LINCOLN CITY/LANCASTER COUNTY PLANNING STAFF REPORT

P.A.S.#: **Muff 2nd Addition**
Change of Zone #3323
Special Permit #1733B
Preliminary Plat #01005

Date: June 13, 2001

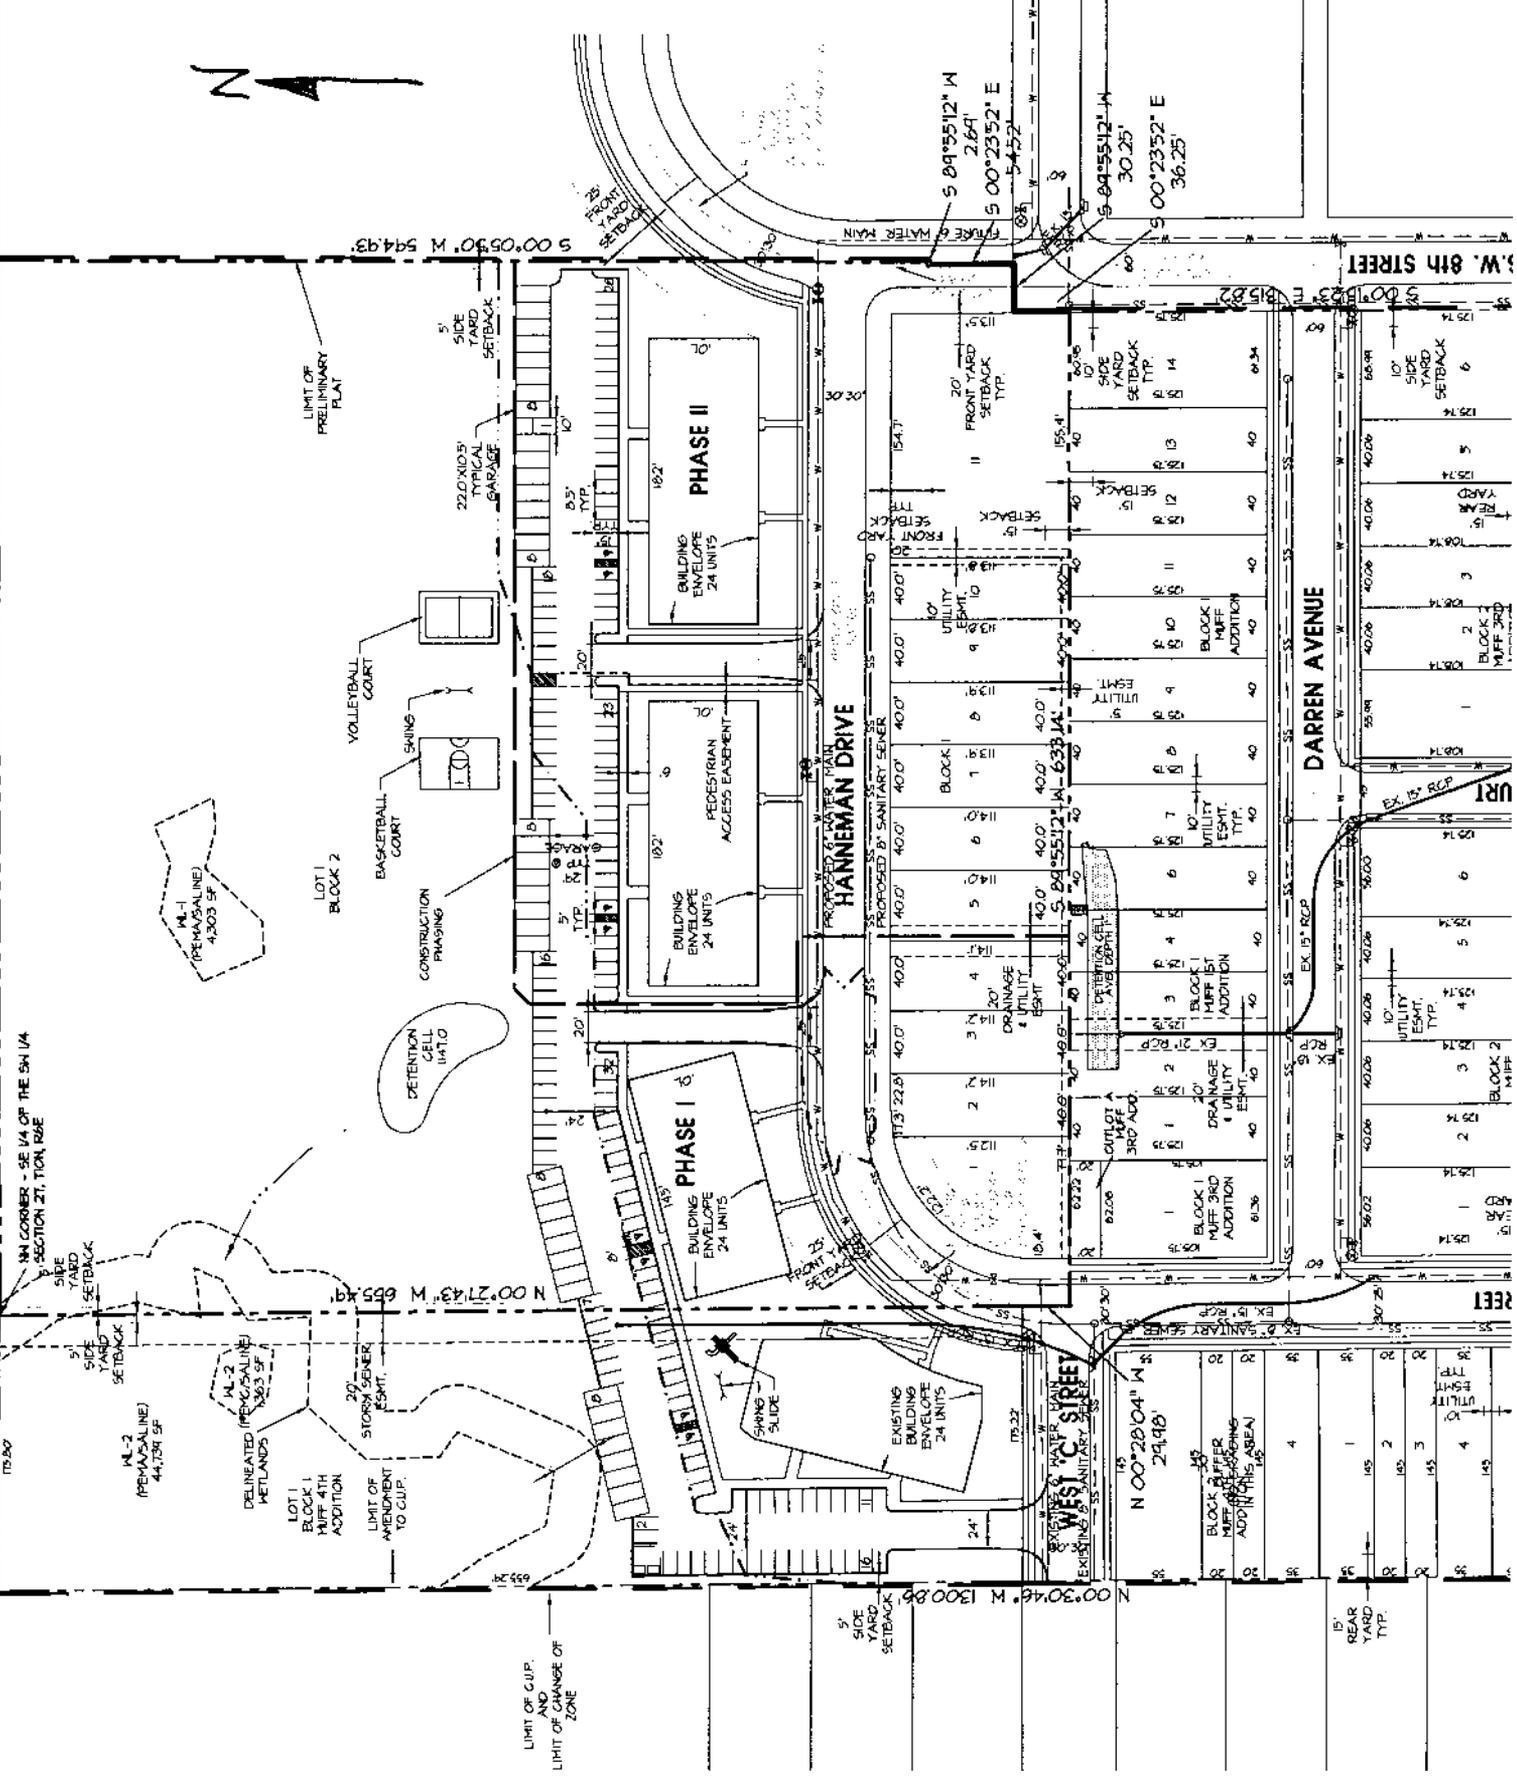
5. The revised drawings show a 15' rear yard setback along the two-family lots. Neither of the previous Muff additions adjusted rear yard setbacks. The two-family lots to the south must provide rear yards equal to 20% of lot depth and this new development should not be treated differently. If the lots do not provide enough buildable area, Hanneman Drive can be moved further north, thus elongating the lots.

6. The first submittal depicted 8 dumpsters scattered along the north side of the parking lot, while the revision shows two in the far northwest corner. At a minimum, additional dumpsters should be located in the northeast corner of the parking area. Eliminating all of the garage enclosures would create 7 additional parking spaces which could be used for trash enclosures.

- 1.1 Revise the site plan to show:
 - 1.1.1 Revisions that were required by the Muff 1st Addition Preliminary Plat.
 - 1.1.2 Remove the “15' rear yard” label from the rear of the new lots. Add a note to the site plan stating, “Required yards shall be according to R-3 zoning.”

- 1.1.3 Remove “Amendment to” before “Community Unit Plan Legal Description”
 - 1.1.4 Remove at least one garage structure and provide additional trash enclosures.
